Proof of Evidence – Highways Matters

Site: Land north of Shaw Lane, Carlton, Barnsley, S71 3HJ

Planning reference: 2022/0115

Appeal Reference: APP/R4408/W/24/3341097

5.4.5 Screenshots from these plans are included below to assist in demonstrating this:

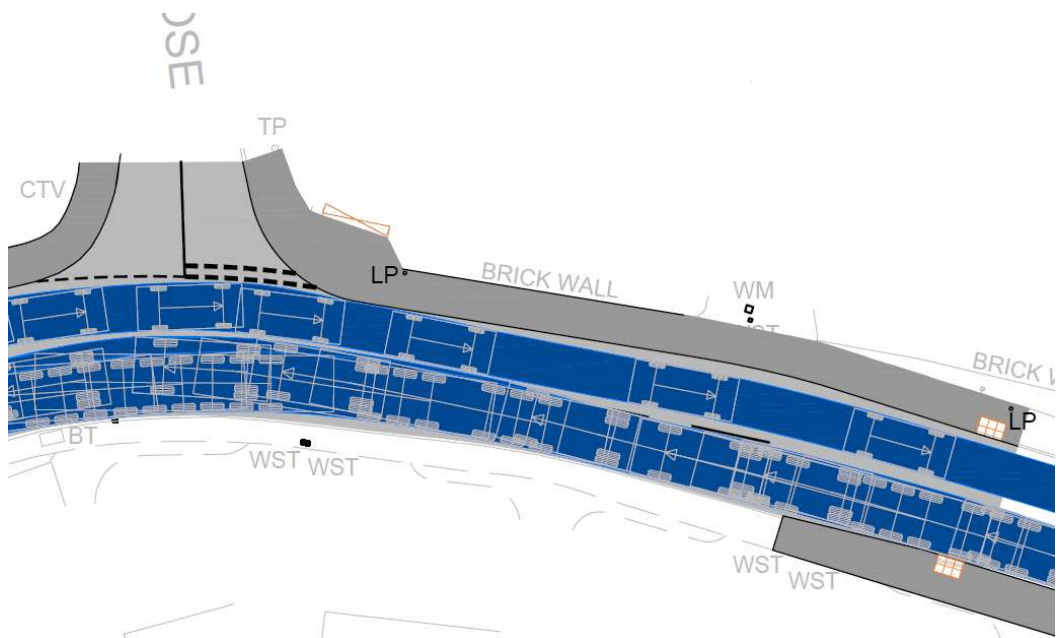
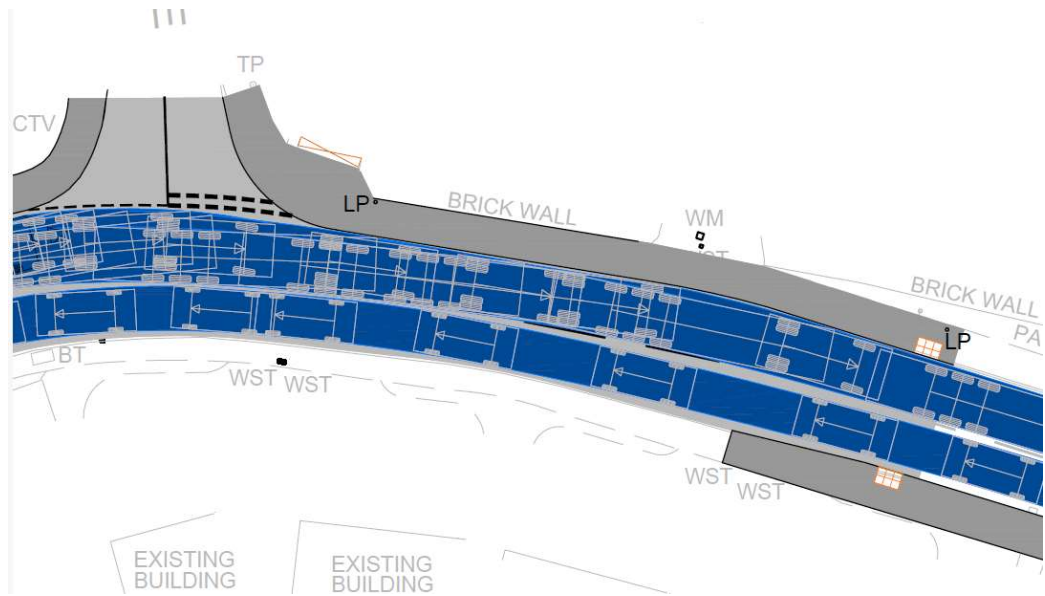
- 5.4.4 Whilst the lack of appropriate swept path analysis identified above fails to demonstrate the full impact of the proposed footway widening and respective carriageway narrowing, plan references IPD-22-580-108 and IPD-22-580-111 clearly demonstrate that opposing movements between a car and HGV cannot be satisfactorily accommodated with adequate margins of safety due to the corresponding reduction in carriageway width. The paths shown indicate a distinct lack of clearance between vehicle body and carriageway edge as well as lack of clearance between vehicles travelling in opposing directions. This is a potential safety hazard for all road users and could result in vehicles colliding or overhanging / overrunning of the footway potentially conflicting with pedestrians which is unacceptable to the Local Authority who have a statutory duty under Section 39 of the Road Traffic Act 1988 to take steps to reduce and prevent

5.4.6 The proposed changes to the footway include the introduction of an uncontrolled crossing point between the northern and southern footways on Shaw Lane approximately 35 metres to the east of Ivy Farm Close without justification. No details were provided to demonstrate that the location is appropriate or that adequate visibility can be achieved in accordance with stopping sight distances specified within Table 15-1 of the Traffic Signs Manual Chapter 6 (See extract below). Furthermore, the unacceptable impact to highway safety identified above is exacerbated at the proposed location for the uncontrolled crossing point by the lack of any horizontal clearance between the HGV and kerb edge.
